RE: Sierra Sunset Park, 10600 Big Springs Rd. SW

**Grading & Drainage Plan**

Engineer's Stamp Date 5-5-2014 (File: N08D003C)

Grading & Drainage Plan

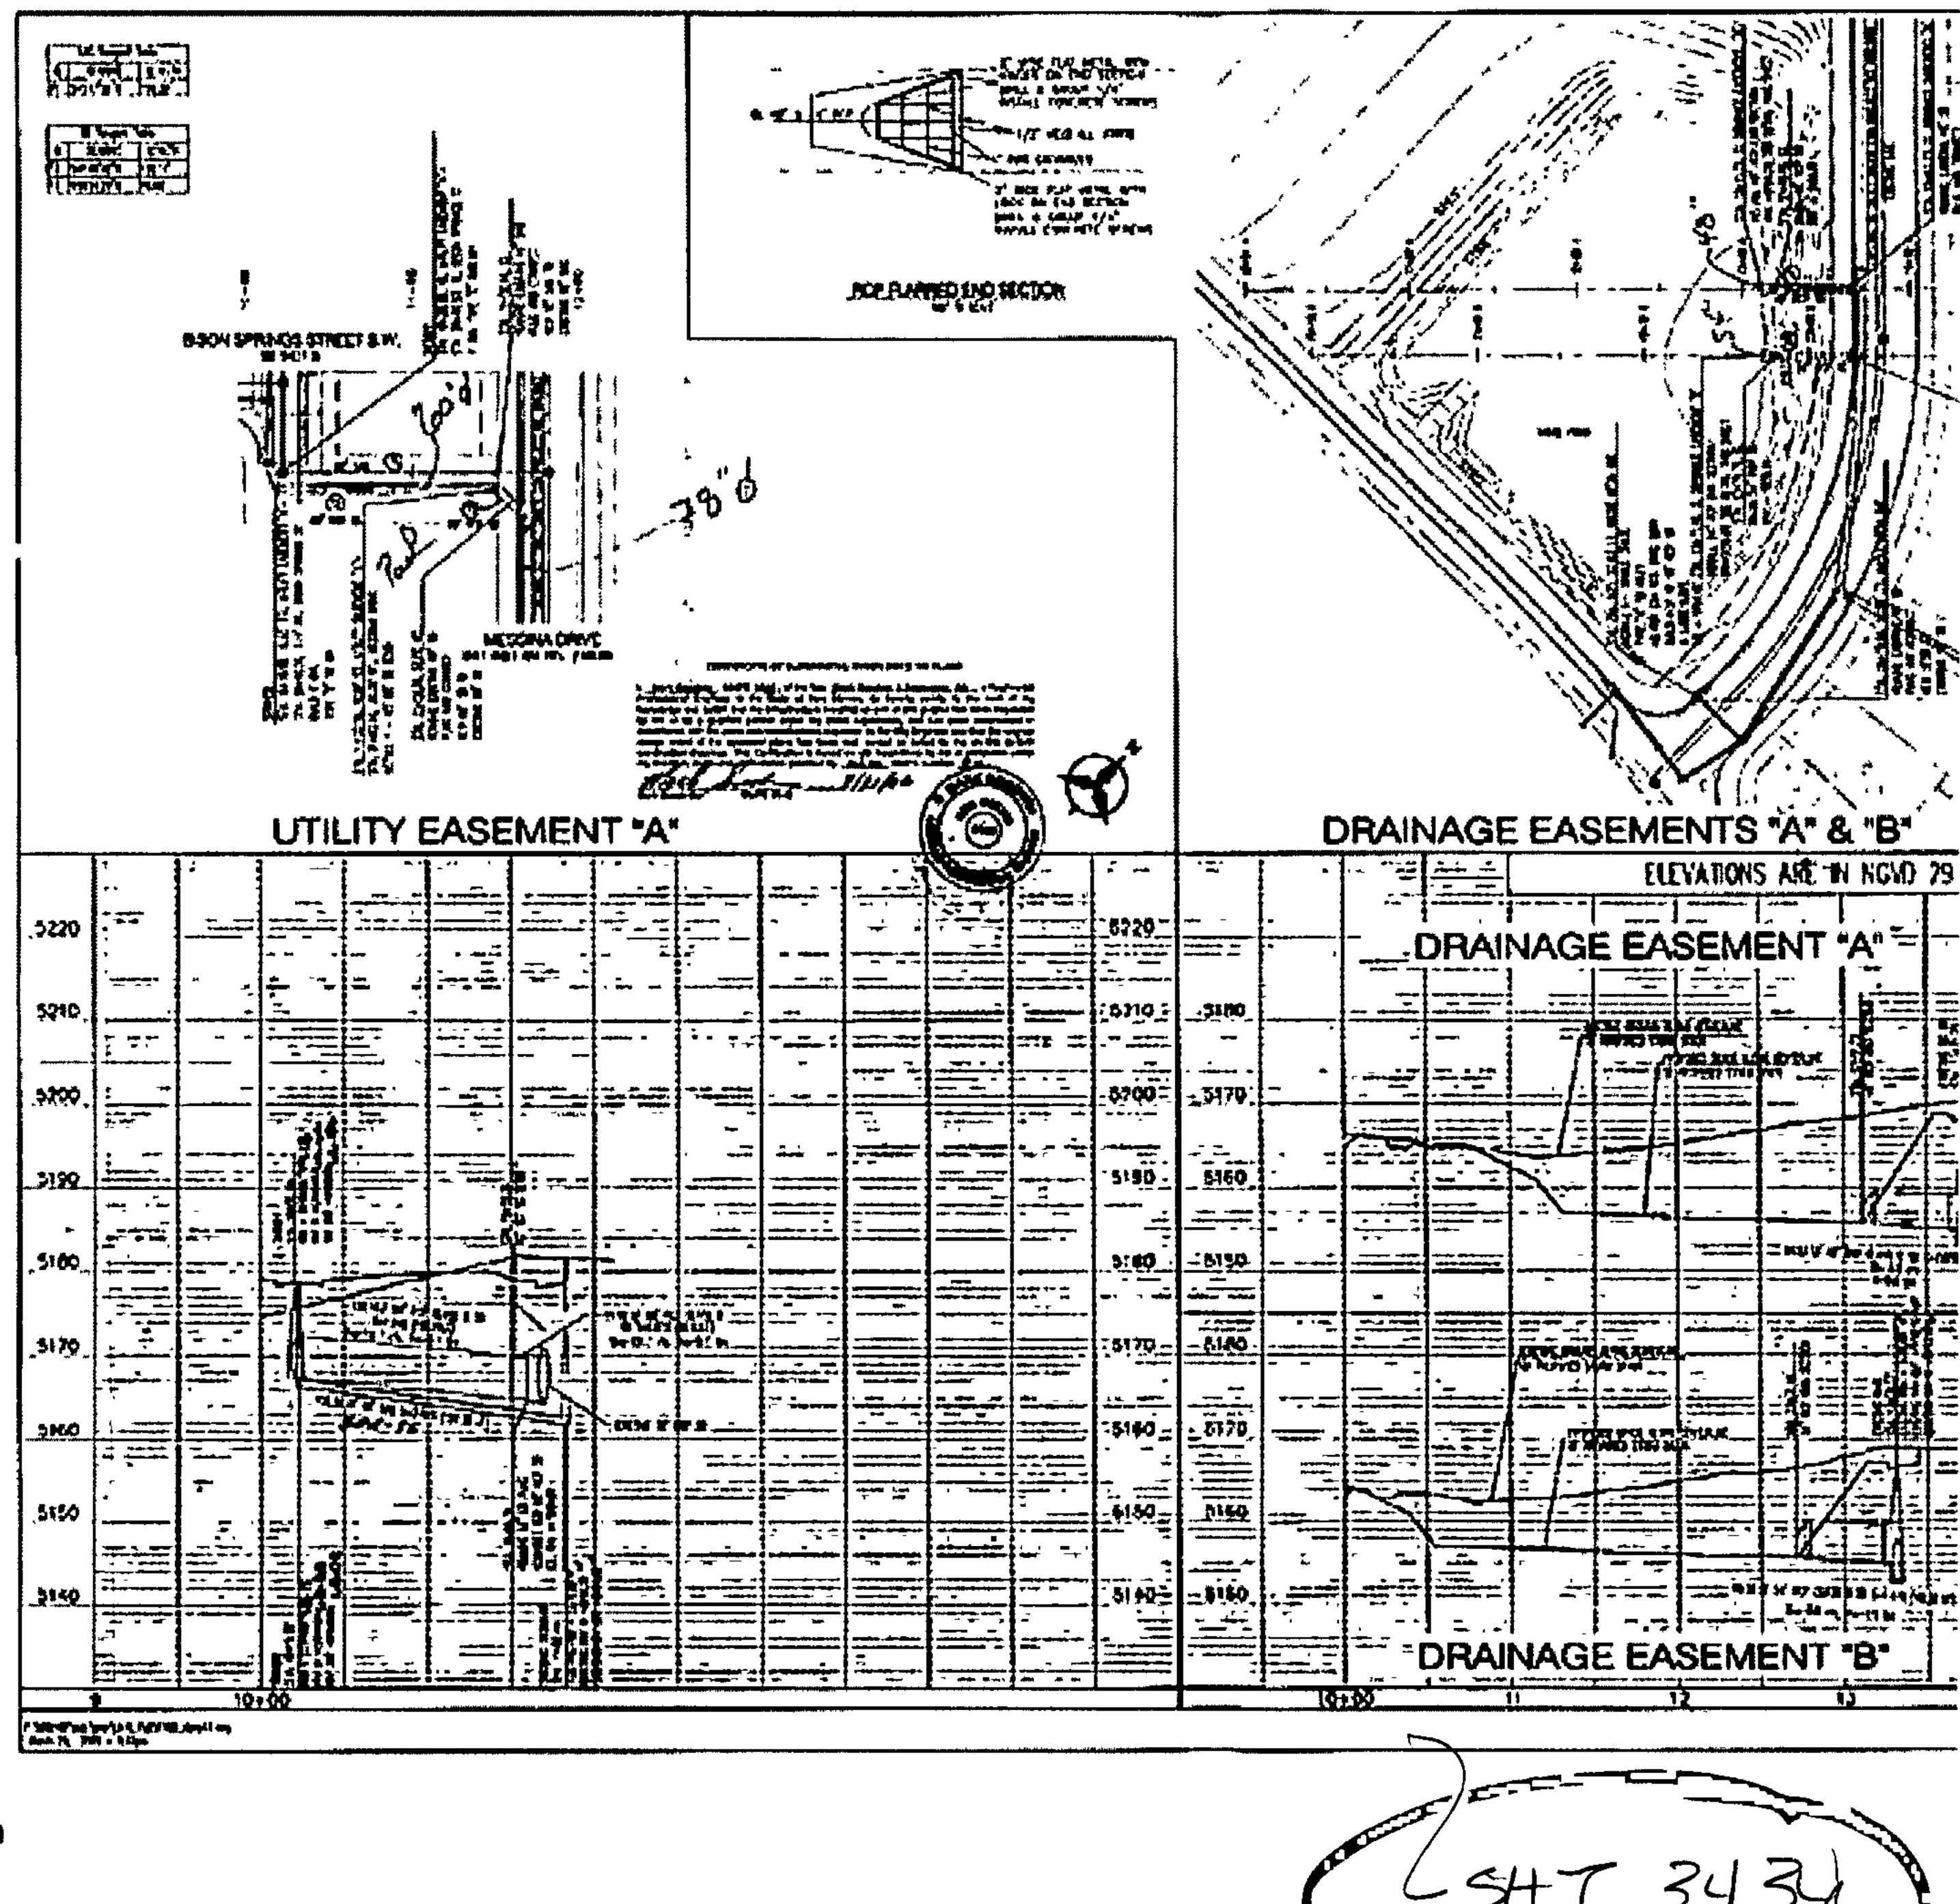
- 1. (see below)Looking at the Drainage Study for the Sierra Ranch Subdivision, the pond volume is 4.2 acre-ft, and the MWSEL is \$160.3 ft (old datum) which would be approx.. 5162.7 ft in new datum. Can you explain the discrepancy in the Pond volume (3500 CY = 2.17 Acre-ft)? The pond volume should be maintained. It seems calculations are in order showing the proposed pond volume, MWSEL, and Emergency Overflow calculations.
- 2. We submitted the plan to AMAFCA and received an email from Lynn Mazur that the surge pond is not an AMAFCA facility. We will eliminate the reference and label it PUBLIC DRAINAGE EASEMENT. AMAFCA will not be reviewing.

Regarding the pond: this surge pond was constructed in 2005 (see as-built below – different datum). In order to use this area for a park, we had to do some minor regrading to establish a slope which would accept sod (6:1). Other than that, we have not altered the pond grades significantly. Based on our preliminary volume calculations for the proposed condition, there is an available volume of 3,500 CY (top of water surface elevation \$161.7)) If the pond were to fill to this elevation, it would spill over at the existing low point and enter Amole Mesa Avenue. We will calculate the volume of the proposed boulders to account for displaced flow if necessary. We estimate approx. 160 boulders @ 2x3x3 with 1/3 buried which would be approximately 71 CY. Is there a specific design volume requirement for this surge pond? I would

- MWSEL fr. Study shows S162,96 (new)

2.17 Az-ft vs 4.2 Arreft why different?

5121.09 new 5118,43 old 2.66 diff
